BYRON - UNITS 1 & 2 3.7.2-2

The purpose of this letter is to provide Revision Q to the referenced ITS submittal. ITS Revision Q (Enclosure 1) contains minor miscellaneous cleanup items for ITS Sections 3.3, 3.6, 3.7, 3.8, 3.9, and 5.0.

Enclosure 1: ITS Revision Q

ITS REVISION Q ITS SECTIONS 3.3/3.6/3.7/3.8/3.9/5.0

BYRON/BRAIDWOOD - UNITS 1 & 2 3.7-11

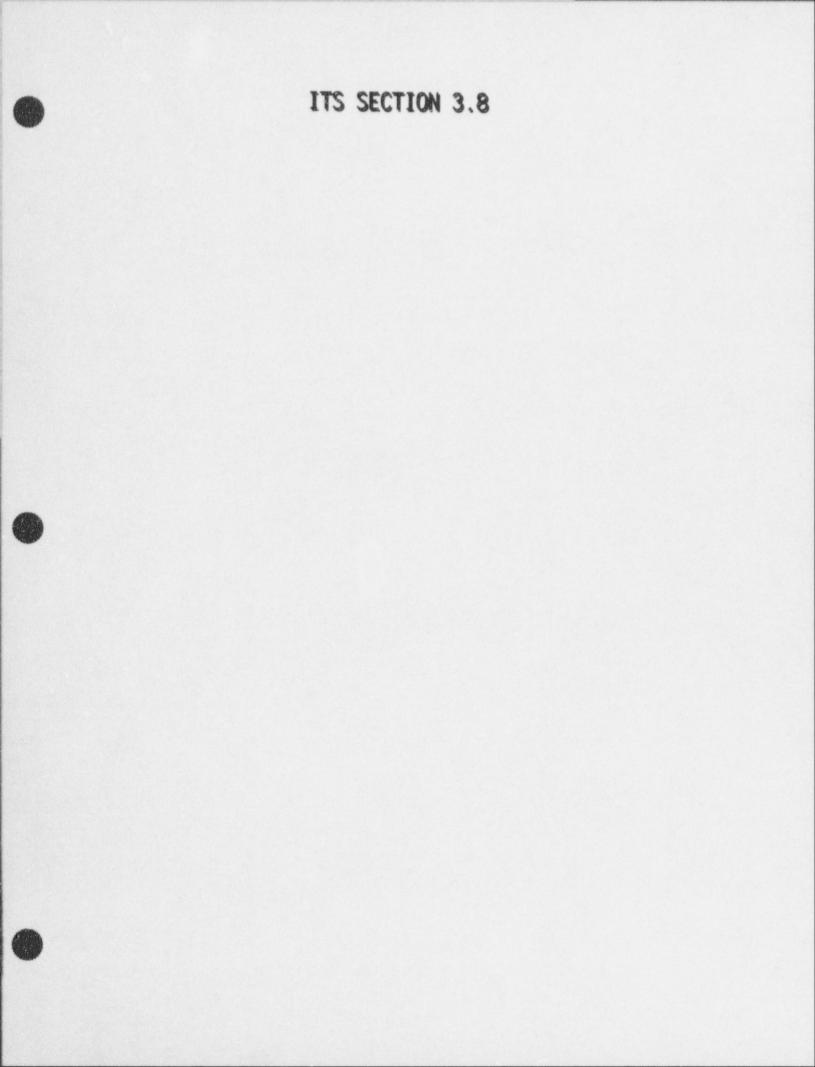
- A42 CTS LCO 3.7.1.1 Action a requires restoration of an inoperable MSSV. NUREG-1431 does not contain the restoration action, but rather relies upon the guidance of LCO 3.0.2 which allows the restoration of a parameter within the time limits of the specified Required Actions. The CTS has been revised to delete this restoration action since the option to restore an inoperable component currently exists in the ITS. During this reformatting, no technical changes (either actual or interpretational) were made to the TS, unless identified and justified. The change is consistent with NUREG-1431 as modified by WOG-83.

- A₄₃ CTS SR 4.7.3.1 requires verification that each valve (manual, power-operated, or automatic) servicing safety-related ... is in its correct position. The Byron and Braidwood CC System does not include any automatic valves. Therefore, the CTS Reference to "automatic" does not have any technical meaning and ITS SR 3.7.7.1 does not include the words automatic. Because the ITS SR accurately reflects the design and intent of the CTS requirement. no technical changes were made to the TS. unless identified and justified.

- A₄₄ By letter dated October 15, 1998, a revision to the Byron and Braidwood CTS for the Nonaccessible Area Exhaust Filter Plenum Ventilation System was received (Amendment # 105 for Byron / Amendment # 97 for Braidwood). Any revisions to the request as a result of the conversion to the ITS are annotated and justified separately.

- A note is added to CTS LCO 3.7.7 (ITS LCO 3.7.12) that allows the Nonaccessible Area Exhaust Filter Plenum Ventilation System alignment requirement to be suspended intermittently under administrative controls for purposes of train realignment. The Nonaccessible Area Exhaust Filter Plenum Ventilation System is required to have two trains aligned for operation and one train aligned in standby because the system design cannot support operation of three trains simultaneously. This note is added to clarify that during realignment of the system there may be a short time period when three inlet dampers may be open or two inlet dampers may be closed. This is an administrative change with no impact on safety because the clarification provided by the Note is consistent with the existing interpretation of the CTS.
